**DATE:** May 10, 2016  
**FROM:** REI Engineers  
**TO:** Bidders of Record  
**REFERENCE:** **Addendum No. 1**  
Buncombe County Schools  
A.C. Reynolds High School Gym Metal Roof Retrofit  
REI Project No. 016CLT-047

**A.C. REYNOLDS  
HIGH SCHOOL  
GYM METAL ROOF  
RETROFIT**

**ROOF PLAN**

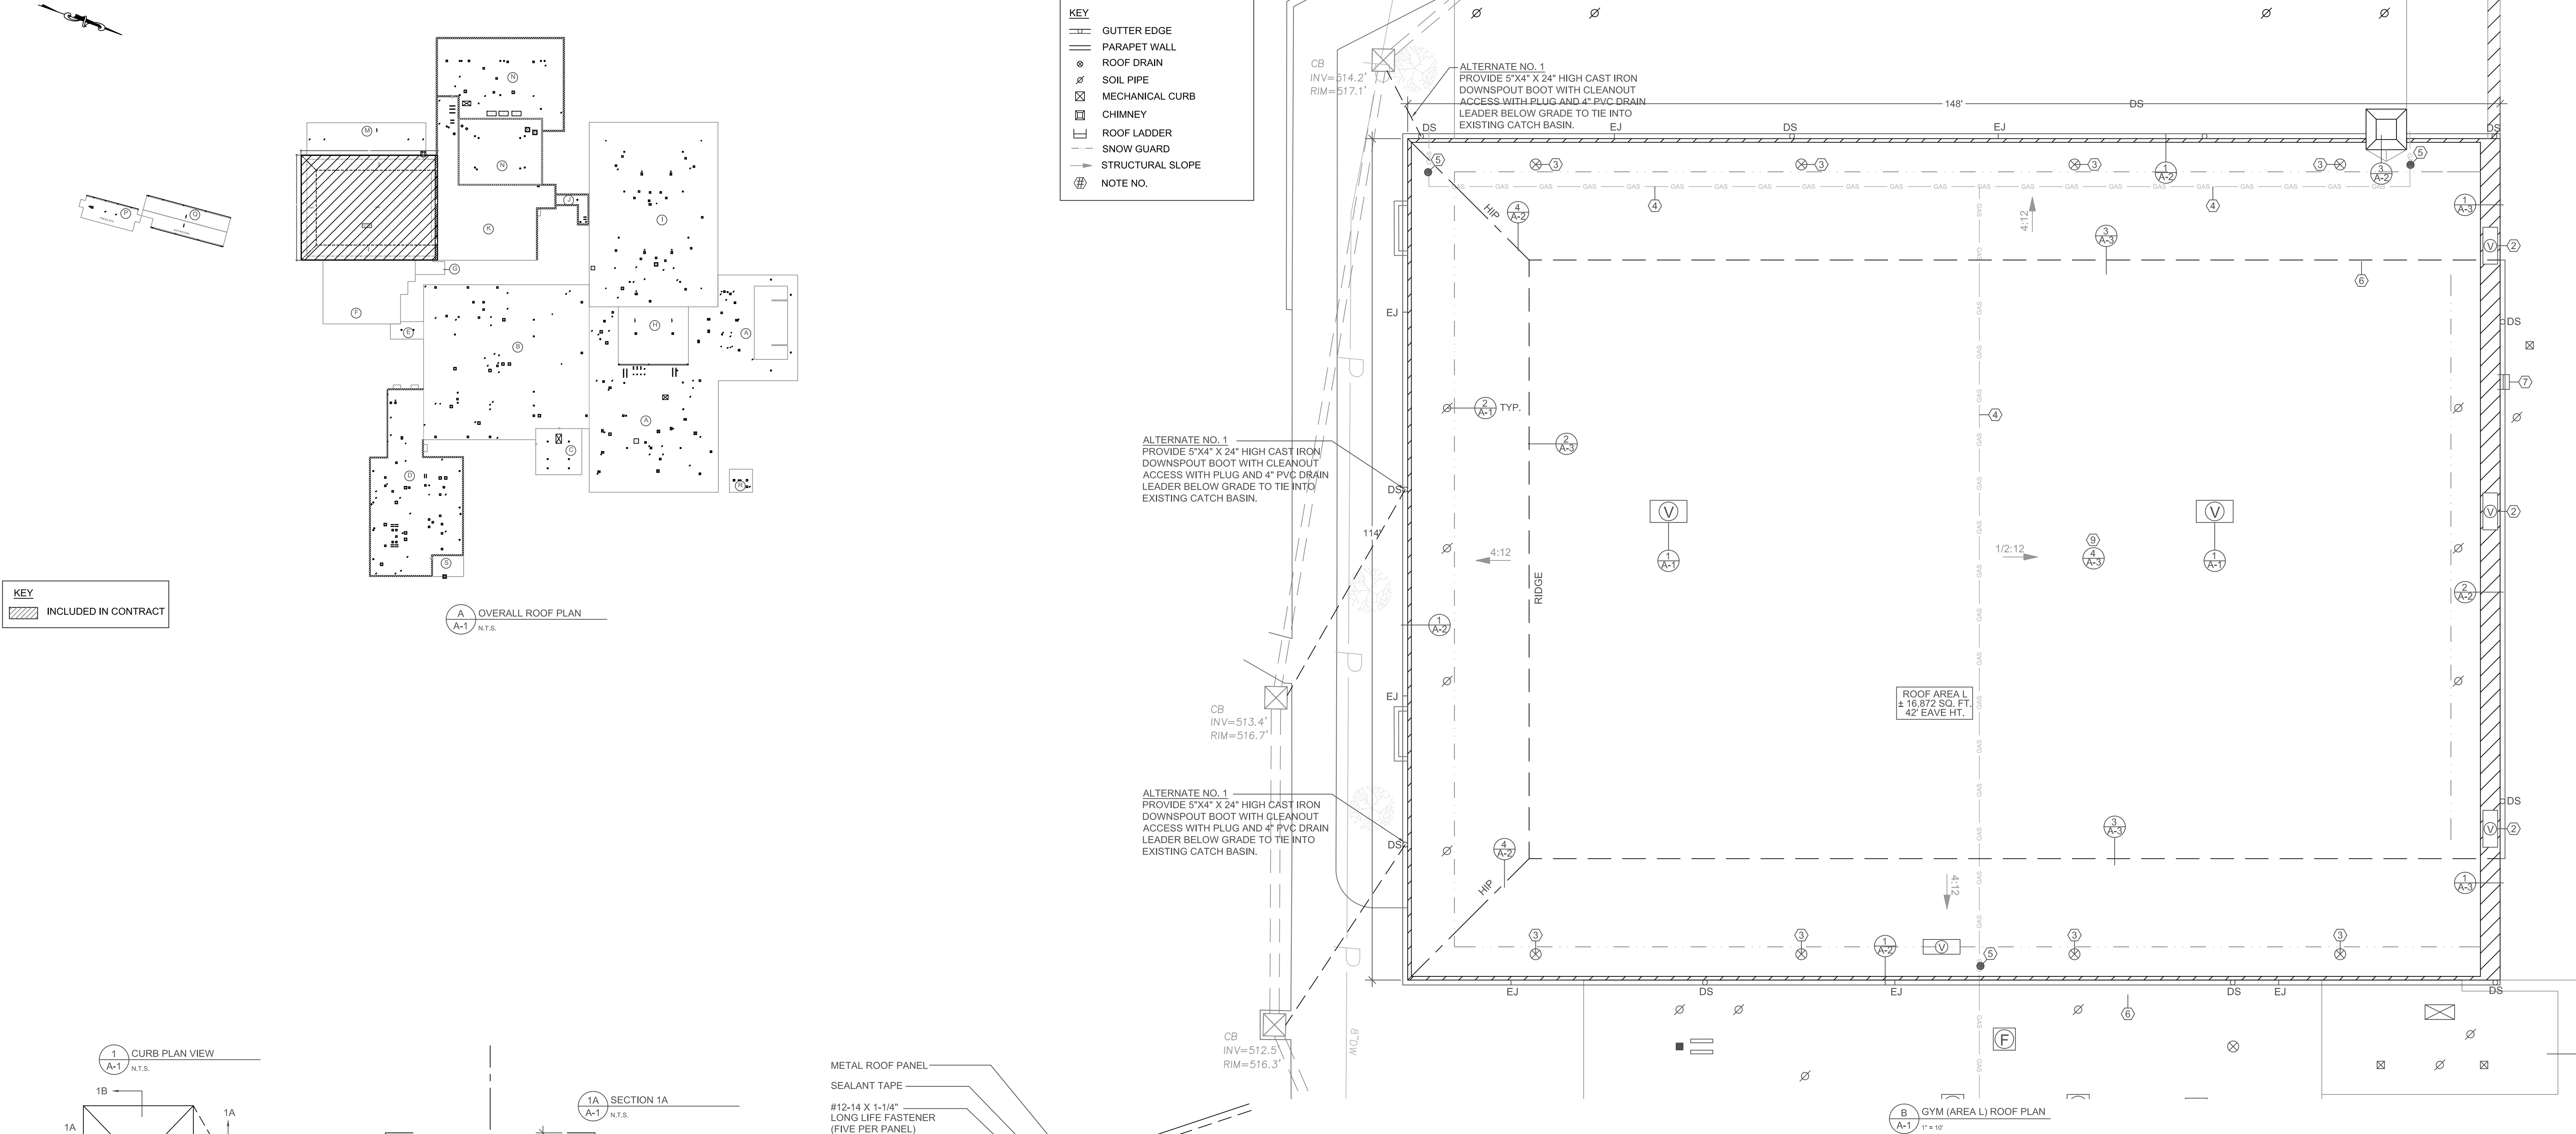
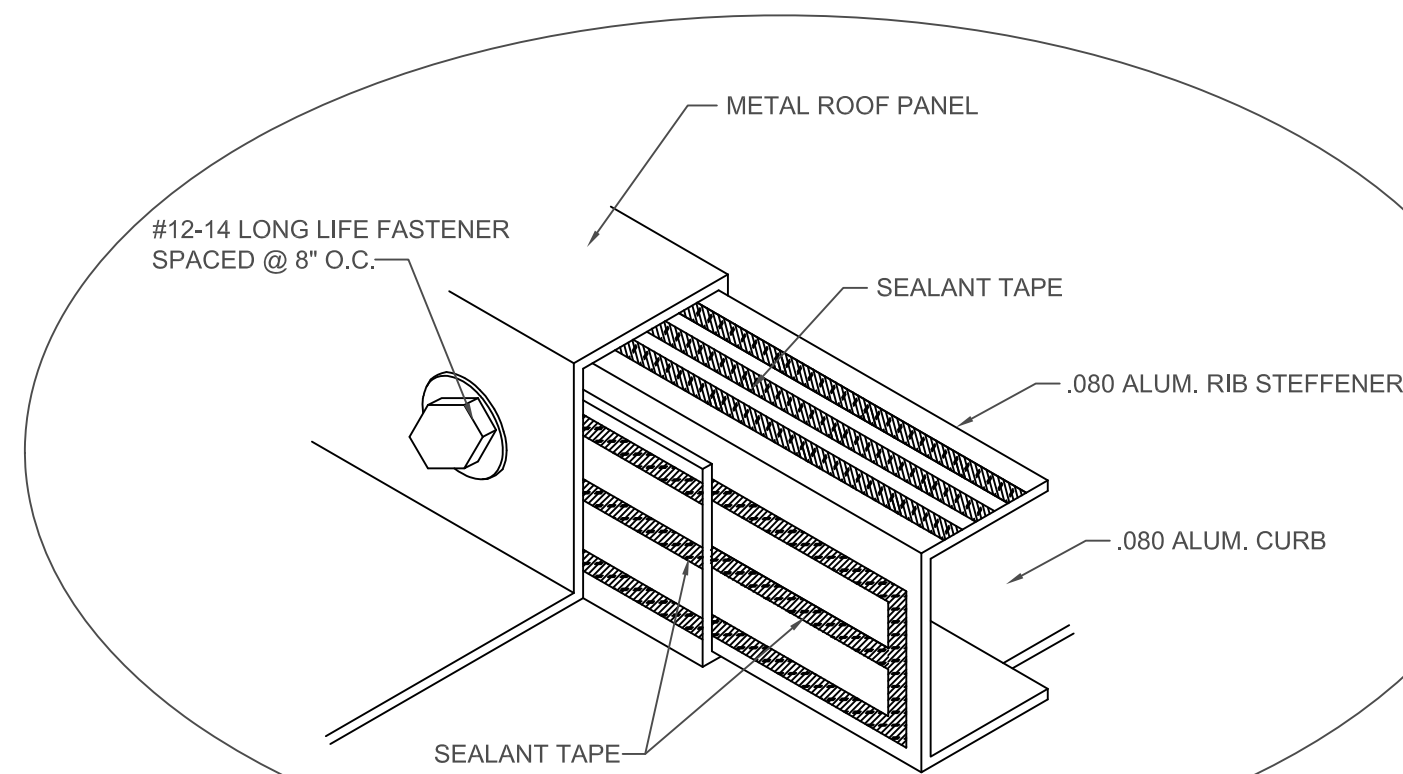
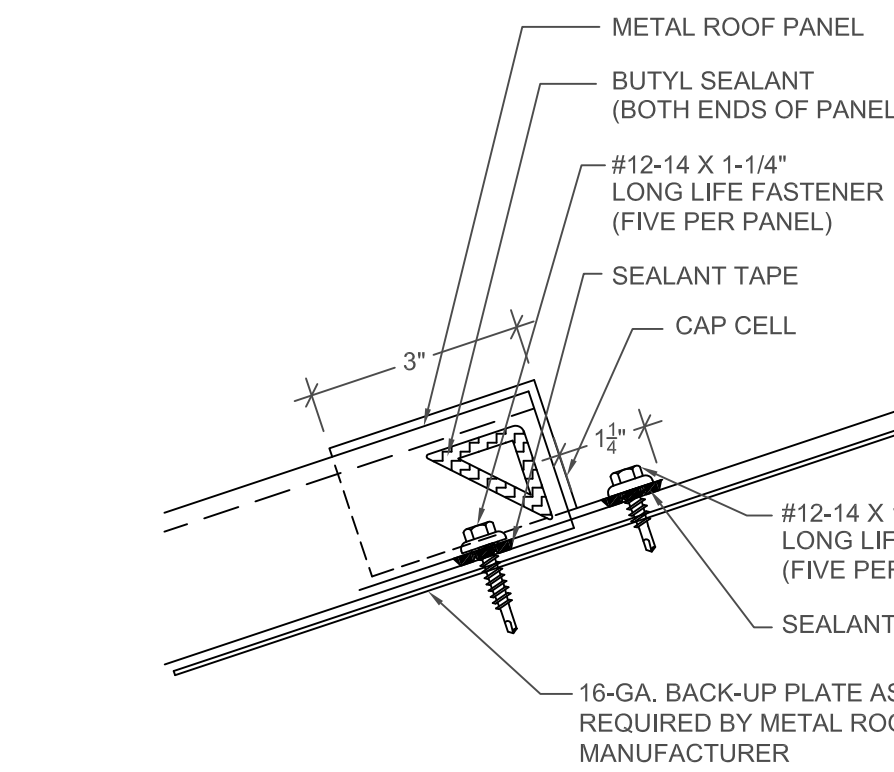
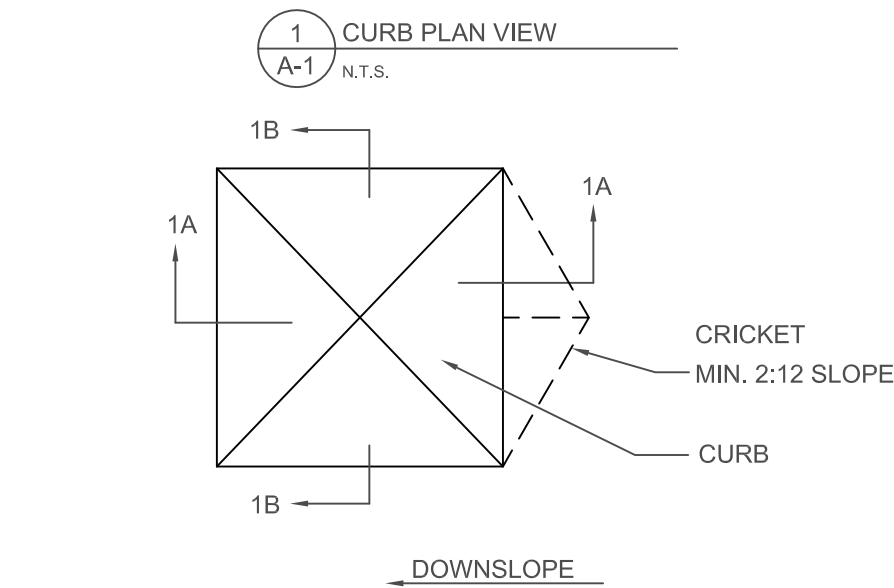
2. Drawing A-1; replace with the attached Revision No. 1 Drawing A-1.

REVISIONS:		
NO.	DATE	DESCRIPTION
1	05/09/16	REVISED ROOF PLAN
